BVY 14-018

SUBJECT: Proposed Changes to the Vermont Yankee Emergency Plan  
Vermont Yankee Nuclear Power Station  
Docket No. 50-271  
License No. DPR-28

The description and evaluation of the proposed SEP changes are contained in Attachment 1. Attachment 2 provides a tabular summary of the proposed changes to the SEP. Attachment 3 provides the revised pages of the SEP with the proposed changes. Attachment 4 provides the post-shutdown on-shift staffing analysis. Attachment 5 provides the analysis of Emergency Response Organization (ERO) tasks that will be transferred to remaining ERO positions.

**Figure 8.1**

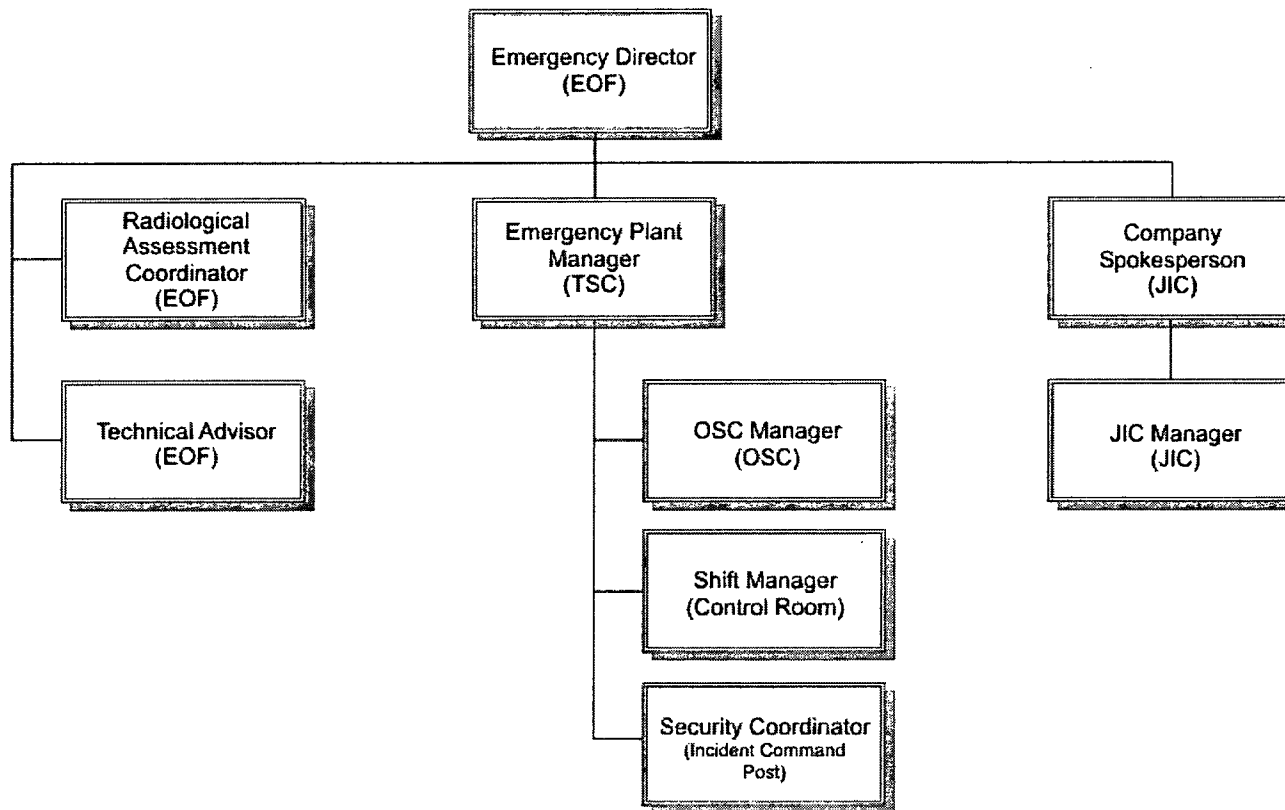
The proposed changes to the on-shift organization are identified in Section 8.1, "Normal Plant Organization," of the SEP, Table 8.4, and Figure 8.1, "Defueled On-Shift Emergency Organization."

<b>Emergency Plan Section</b>	<b>Before (Rev. 54)</b>	<b>After</b>	<b>Reason for Change</b>
Table of Contents	--	Updated page numbers as necessary	Editorial revision to reflect changes described below.
Table of Contents – List of Figures	Figure 8.1 Normal On-Shift Emergency Organization	Figure 8.1 Defueled On-Shift Emergency Organization	VY will no longer be an operating nuclear power plant. The title change reflects the permanently defueled organizational structure.
Table of Contents – List of Figures	Figure 8.2 Vermont Yankee Emergency Management Organization	Figure 8.2 Vermont Yankee Defueled Emergency Management Organization	VY will no longer be an operating nuclear power plant. The title change reflects the permanently defueled organizational structure.
Table of Contents – List of Figures	Figure 8.3 Technical Support Center Emergency Organization	Figure 8.3 Defueled Technical Support Center Emergency Organization	VY will no longer be an operating nuclear power plant. The title change reflects the permanently defueled organizational structure.

**Defueled On-shift Emergency Organization.**

**Figure 8.2**

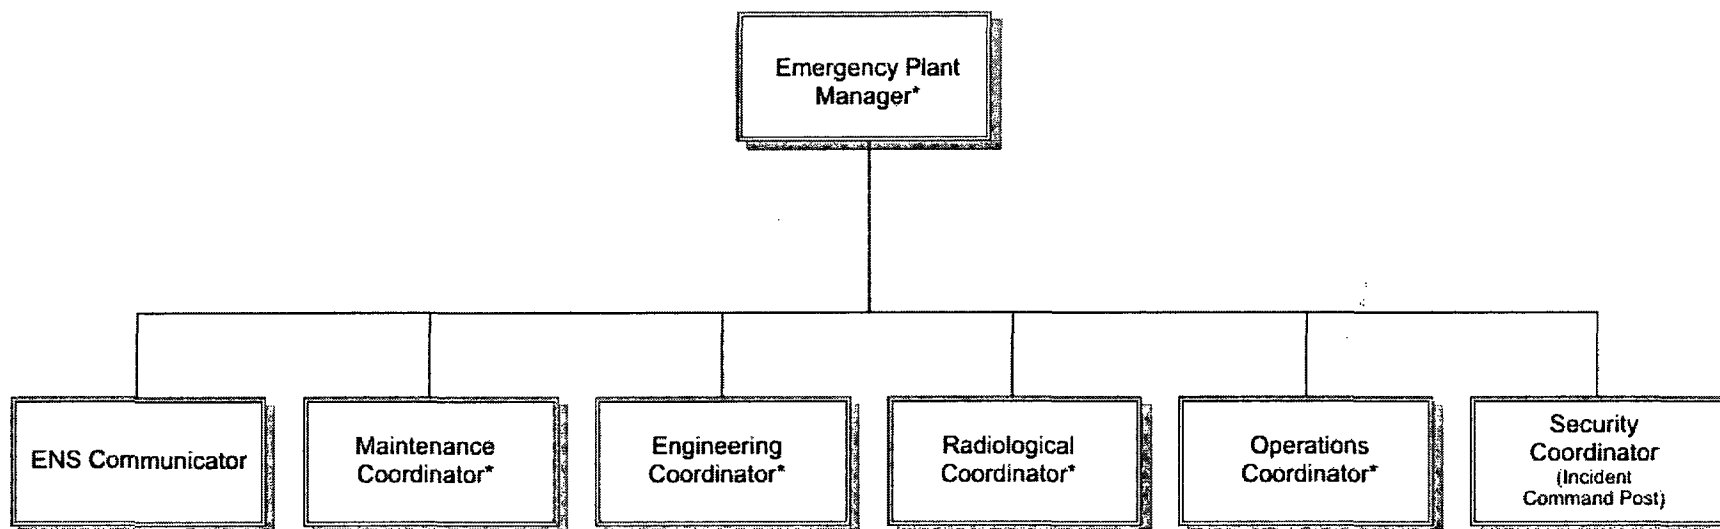
The proposed changes to the SEP will also eliminate non-minimum (i.e., not required for facility activation) ERO positions currently identified in Table 8.3, "A Summary of Offsite Coordination," Figure 8.2, "VY Emergency Management Organization," Figure 8.3, "Technical Support Center Emergency Organization," Figure 8.4, "Operations Support Center Emergency Organization," Figure 8.5, "Emergency Operations facility Organization," Figure 8.7, "Joint Information Center Organization," and Table 9.1, "Vermont Yankee Emergency Response" Specific positions identified for elimination are listed in Table 1 of this attachment.

<b>Figure 7.2</b>	Coordination Channels with States
<b>Figure 8.1</b>	<del>Normal</del> <u>Defueled</u> On-Shift Emergency Organization
<b>Figure 8.2</b>	Vermont Yankee <u>Defueled</u> Emergency Management Organization
<b>Figure 8.3</b>	<u>Defueled</u> Technical Support Center Emergency Organization
<b>Figure 8.4</b>	<del>Operations Support Center Emergency Organization</del> <u>(Deleted)</u>
<b>Figure 8.5</b>	<u>Defueled</u> Emergency Operations Facility Organization
<b>Figure 8.6</b>	(Deleted)
<b>Figure 8.7</b>	<u>Defueled</u> Joint Information Center Organization

**VY Defueled Emergency Management Organization**

**Figure 8.3**

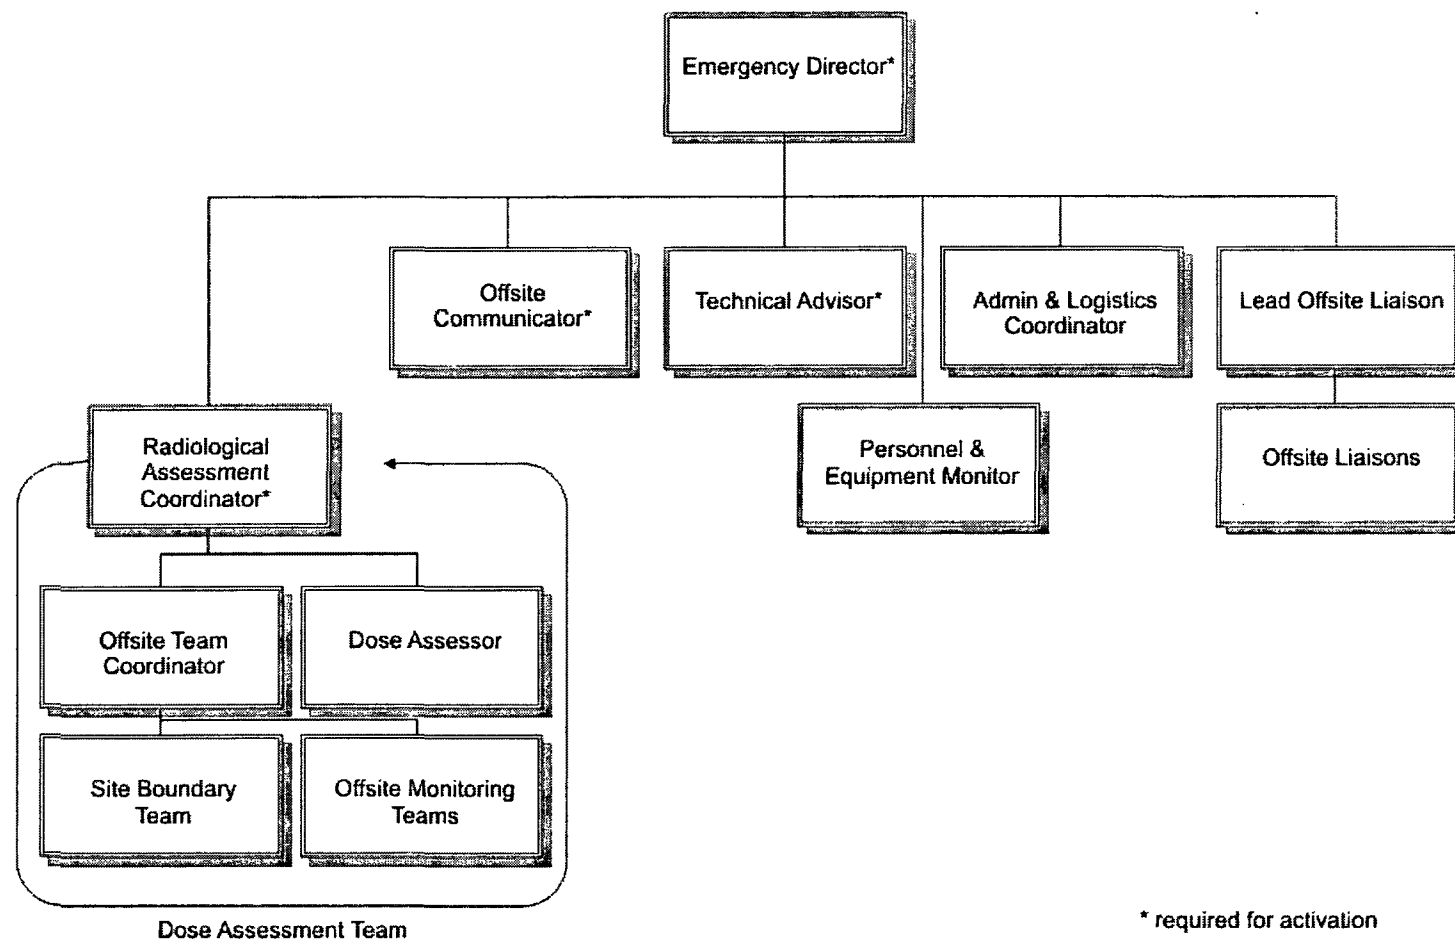
Figure 8.3	Technical Support Center Emergency	Replaced figure with "Defueled	The TSC positions identified for

Emergency Plan Section	Before (Rev. 54)	After	Reason for Change
	Organization	<p>Technical Support Center Emergency Organization"</p> <p>Deleted the following positions:</p> <ul style="list-style-type: none"> <li>• TSC Manager</li> <li>• TSC Communicator</li> <li>• Mechanical Engineer</li> <li>• Reactor Engineer</li> <li>• Electrical /I&amp;C Engineers</li> <li>• IT Specialist</li> </ul>	deletion will not exist in the Permanently Defueled ERO. Duties and responsibilities will be transferred to remaining positions within the TSC.
Figure 8.4	Operations Support Center Emergency Organization	Deleted figure	ERO Staffing changes result in one remaining OSC position (OSC Manager) – A figure is no longer necessary to describe the OSC organization.
Figure 8.5	Emergency Operations Facility Organization	<p>Replaced figure with "Defueled Emergency Operations Facility Organization"</p> <p>Deleted the following positions:</p> <ul style="list-style-type: none"> <li>• EOF Manager</li> <li>• EOF Communicator</li> <li>• Public Information Liaison</li> <li>• EOF Log Keeper</li> <li>• IT Specialist</li> </ul>	The EOF positions identified for deletion will not exist in the Permanently Defueled ERO. Duties and responsibilities will be transferred to remaining positions within the EOF.

**Defueled Technical Support Center Emergency Organization**

**Figure 8.5**

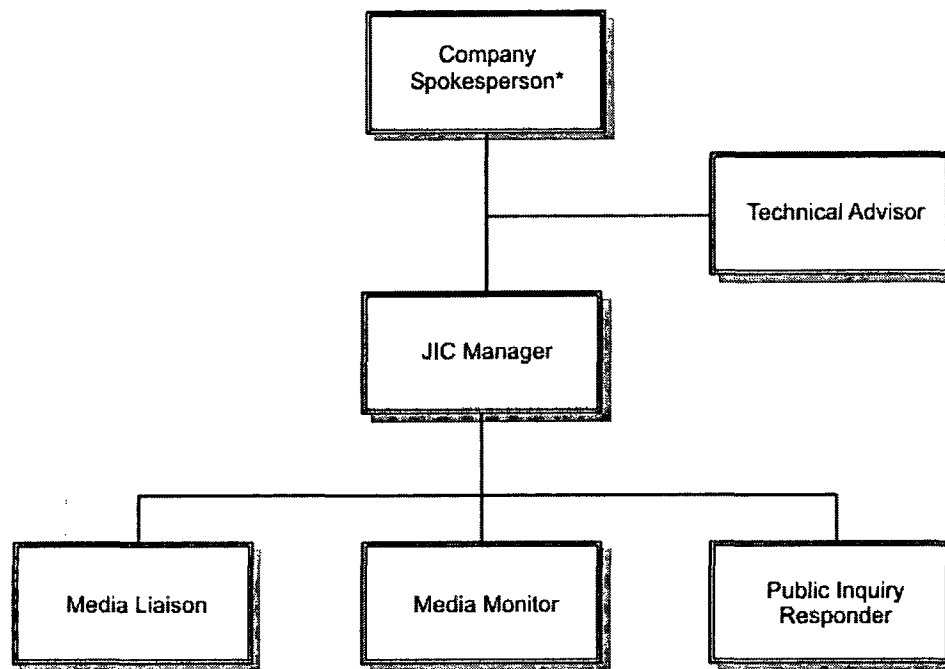
“ENVY has designated ERO members who staff positions required to meet minimum staffing to activate the TSC, OSC and EOF. The minimum staff positions required to activate the TSC and EOF are shown in E Plan Figures 8.3 and 8.5. The OSC Manager is the only position required to activate and staff the OSC. All ERO personnel are expected to respond when notified by the emergency call-in notification system.”

**Defueled Emergency Operations Facility Organization**
